Site Plan Review Committee (SPRC)
Staff Report for
2025 Fairfax Drive (Wakefield Manor)
SPLN22-00001

2025 Fairfax Drive (SPLN22-00001)
Wakefield Manor
(RPC #17-017-002, -005, -006)

Item 1. 2025 Fairfax Drive (SPLN22-00001)

Figure 11. Proposed Site Layout

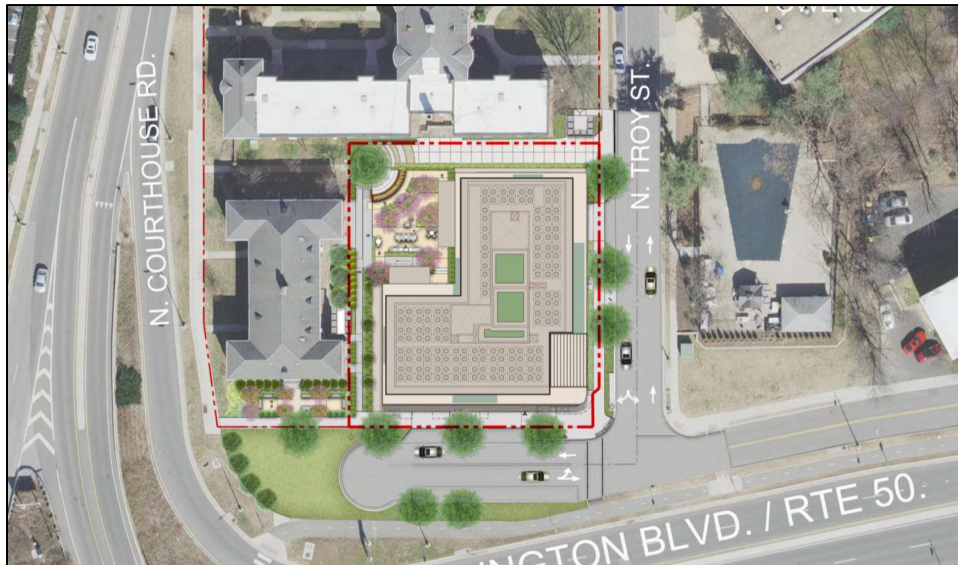
Site Design & Layout: The applicant proposes a residential building with 2 levels of below-grade parking and 2 levels of above-grade parking. The building meets the sidewalk on Fairfax Drive and is setback approximately 3 ft from the sidewalk on North Troy Street. Due to the grade change of approximately 12 ft as it slopes down from the northern edge of the building to Fairfax Drive, portions of both the ground floor and mezzanine level have at-grade street frontages. The ground floor uses include the residential entrance, lobby, and parking and loading access. The mezzanine level uses include a residential amenity space and the 30 residential parking spaces for use by the current residents of Courthouse Manor and Wakefield Manor. A single curb cut is located on North Troy Street for parking access, while two curb cuts are located on Fairfax Drive for parking and loading access. The applicant also proposes an approximately 2,400 sf elevated private courtyard in the northwest corner of the building on the second level. A pedestrian walkway and maintenance access runs along the north side of the building, while a pedestrian only walkway runs along the west side of the building. Other than the location of the underground utility vaults between Fairfax Drive and the Wakefield

Figure 27. Proposed Conceptual Landscape Plan

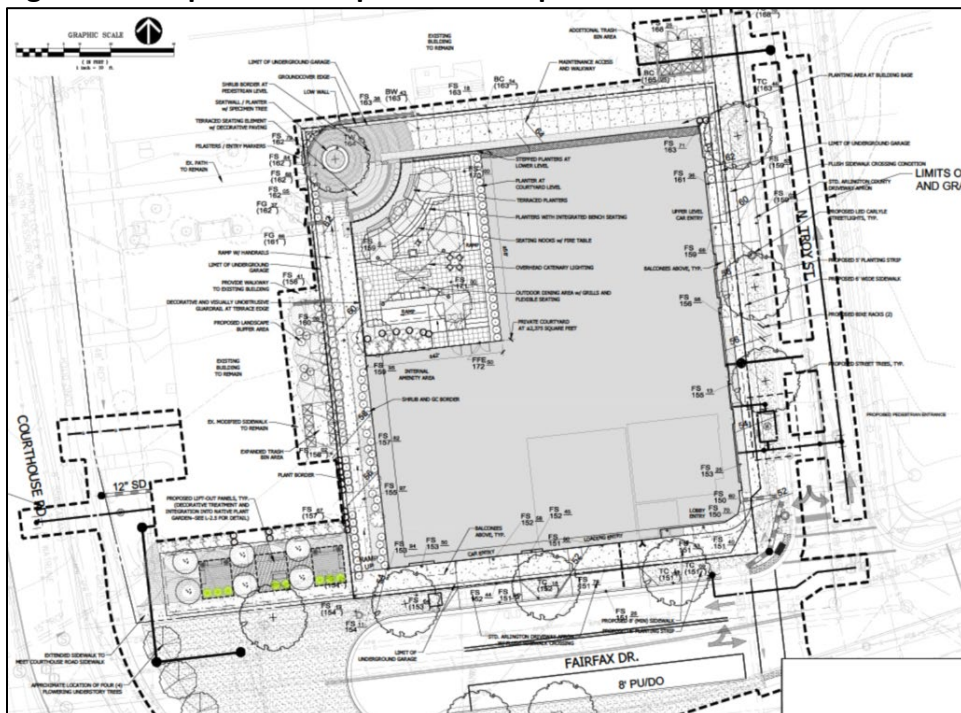
Open Space and Landscaping: The applicant proposes an approximately 2,400 sf elevated private courtyard in the northwest corner of the building with outdoor grills and seating, as well as planting beds for trees and shrubs. Curved terrace seating is located in the northwest corner of the elevated courtyard to create a more gradual transition down to the paved pathway and central canopy tree. The paved pathways between the new development and existing buildings to the north and west are proposed to be lined with tree plantings, shrubs and green walls screening the mezzanine level. To introduce more biophilic elements around the proposed location of the underground utility vault lift-out panels, the applicant proposed enhanced landscaping including native plantings, a butterfly garden and decorative pavers. The project also includes an outdoor amenity area on the building's top floor and 7 new street trees on Fairfax Drive and North Troy Street. Additional trees are proposed to be planted on the south side of the cul-de-sac and adjacent to the Arlington Boulevard off-ramp. Within the limits of disturbance, approximately 10 trees are proposed to be removed and replaced per the County's tree replacement standards. This includes a white oak, which is identified by staff as a

significant tree in the FMHN Plan. Overall, the applicant is proposing a tree canopy coverage of approximately 8%.

Figure 29. Existing (top) and Proposed (bottom) Fairfax Drive Cross-section

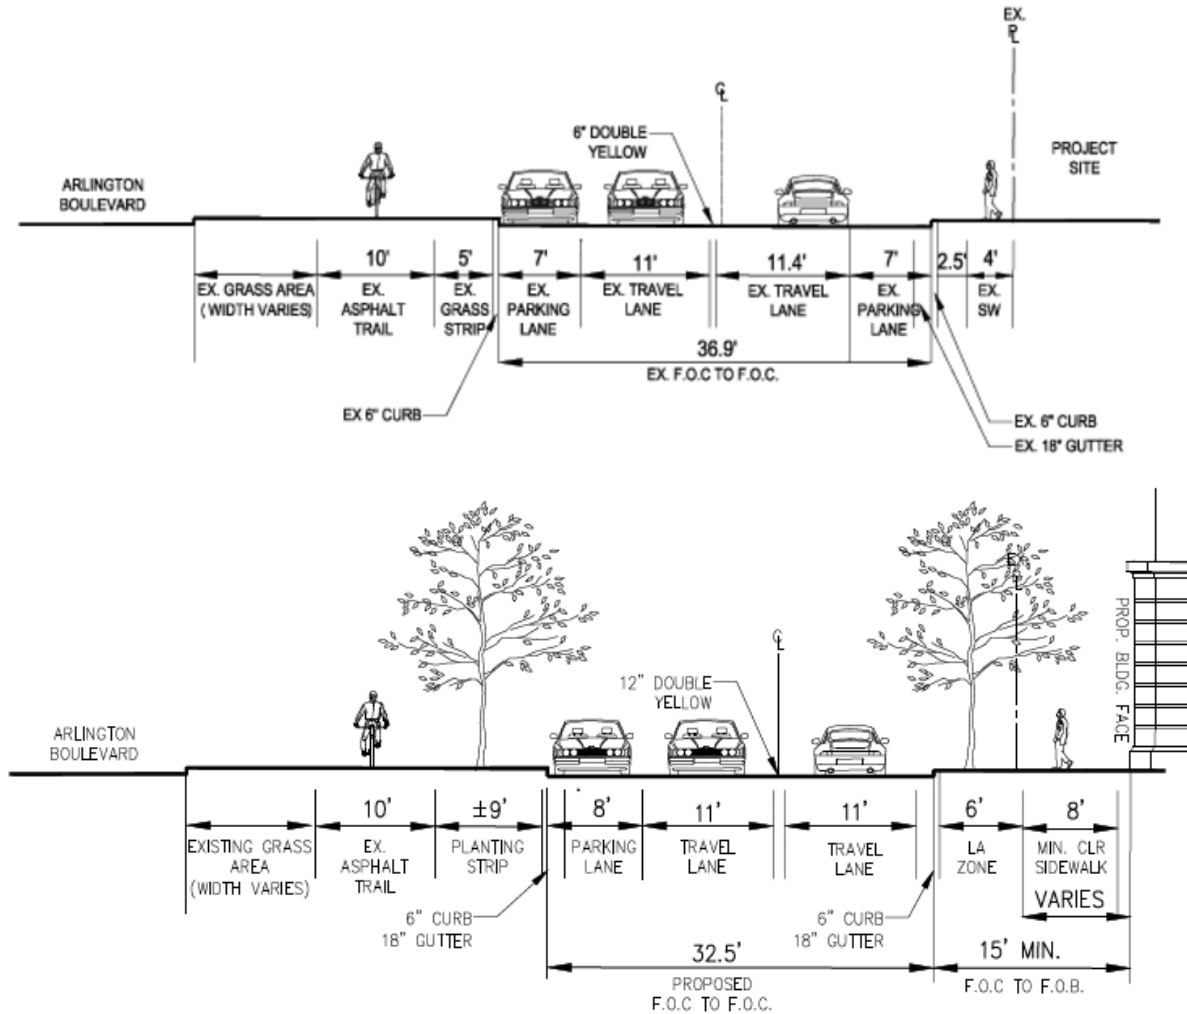
Fairfax Drive: The block is bounded by Fairfax Drive to the south, which has an existing curb-to-curb street width of approximately 36.9 ft and consists of 2 travel lanes and 2 parking lanes on each side. Fairfax Drive also dead-ends just west of the new development, in front of the existing Wakefield Manor building. Parallel to Fairfax Drive is Arlington Boulevard and the Arlington Boulevard multi-use trail. Similar to the improvements as part of the approved site plan, the applicant is proposing to remove the existing parking lane on the north side of the

street and convert the dead-end area into a cul-de-sac. The parking lane on the south side of Fairfax Drive will remain, with the planting strip between Fairfax Drive and the Arlington Boulevard trail increasing from approximately 5 ft to 9 ft. The proposed streetscape will consist of an expanded 8 ft sidewalk, 6 ft landscaped buffer and an approximate 0.5 ft shy zone. The Master Transportation Plan (MTP) identifies this section of Fairfax Drive as a Neighborhood non-arterial, which recommends a 4 to 6 ft sidewalk and a 2 to 4 ft landscaping strip. The FMNH Plan recommends an 8 ft sidewalk, including a 5 to 6 ft landscaping strip.

Figure 30. Existing (top) and Proposed (bottom) North Troy Street Cross-section

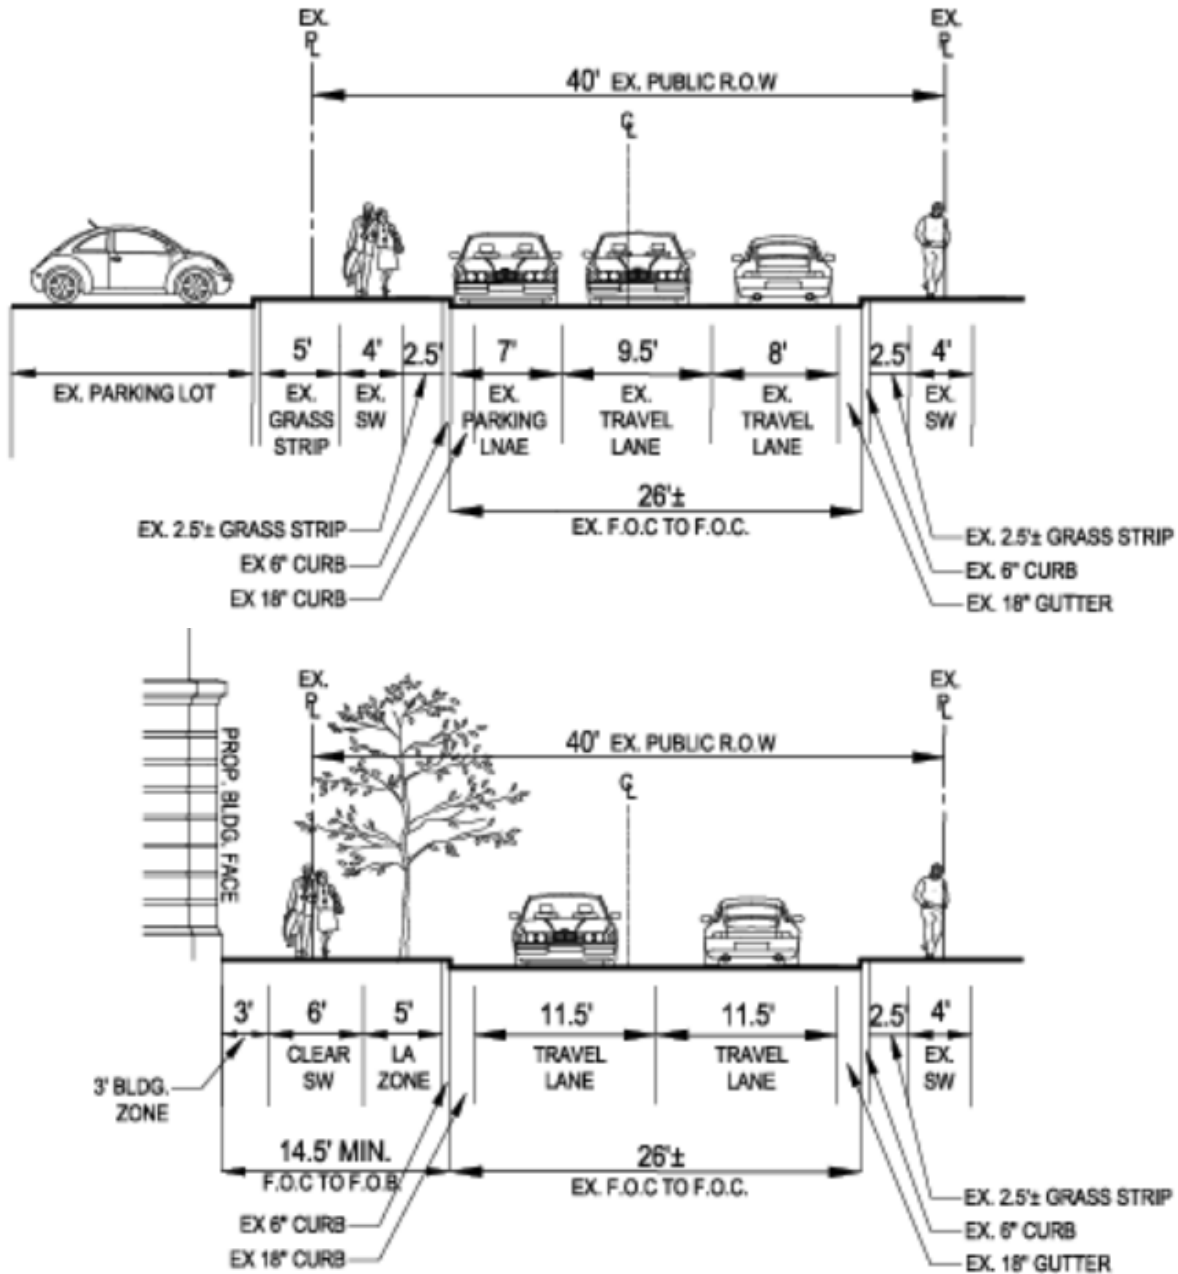
North Troy Street: The block is bounded by North Troy Street to the east, which has an existing curb-to-curb street width of approximately 26 ft and consists of 2 travel lanes and 1 parking lane on the southbound side of the street. While no changes are proposed to the curb-to-curb street width, the applicant is proposing to remove the existing parking lane. The proposed streetscape will consist of an expanded 6 ft sidewalk, 5 ft landscaped buffer and an approximate 3 ft shy zone. The MTP identifies this section of North Troy Street as a

Neighborhood non-arterial, which recommends a 4 to 6 ft sidewalk and a 2 to 4 ft landscaping strip. The FMNH Plan recommends a 6 ft sidewalk, including a 5 to 6 ft landscaping strip.

Figure 31. Existing (top) and Proposed (bottom) 13th Street North Cross-section

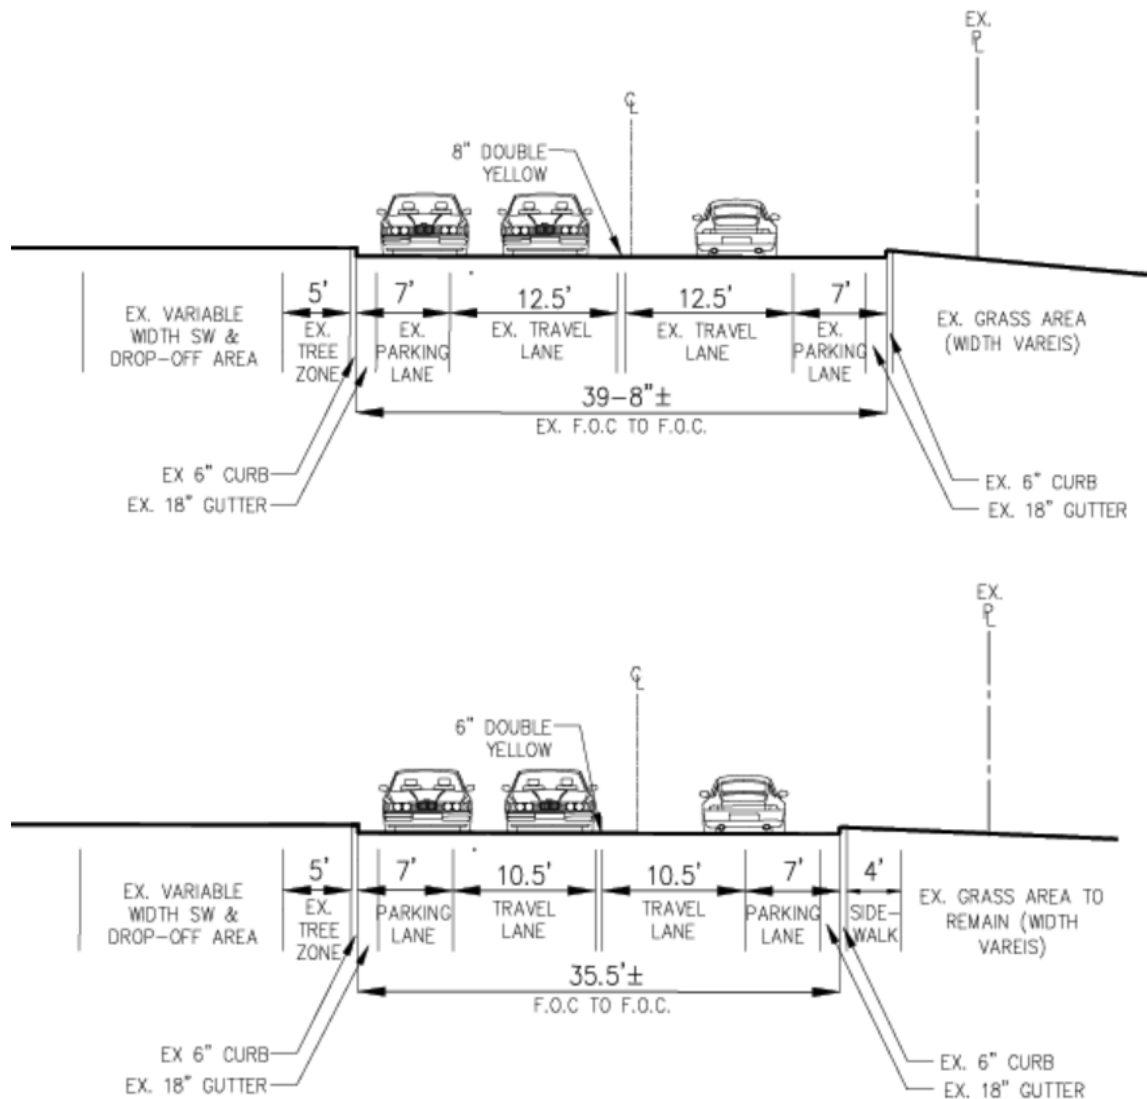
13th Street North: The block is bounded by North Troy Street to the north, which has an existing curb-to-curb street width of approximately 39.7 ft and consists of 2 travel lanes and parking lanes on each side. The applicant is proposing to reduce the curb-to-curb street width to approximately 35.5 ft while keeping the 2 travel lanes and 2 parking lanes. The proposed streetscape will consist of a new 4 ft sidewalk on the south side of the street adjacent to the

block. The MTP identifies this section of 13th Street North as a Neighborhood non-arterial, which recommends a 4 to 6 ft sidewalk and a 2 to 4 ft landscaping strip. The FMNH Plan recommends a 6 ft sidewalk, including a 5 to 6 ft landscaping strip.
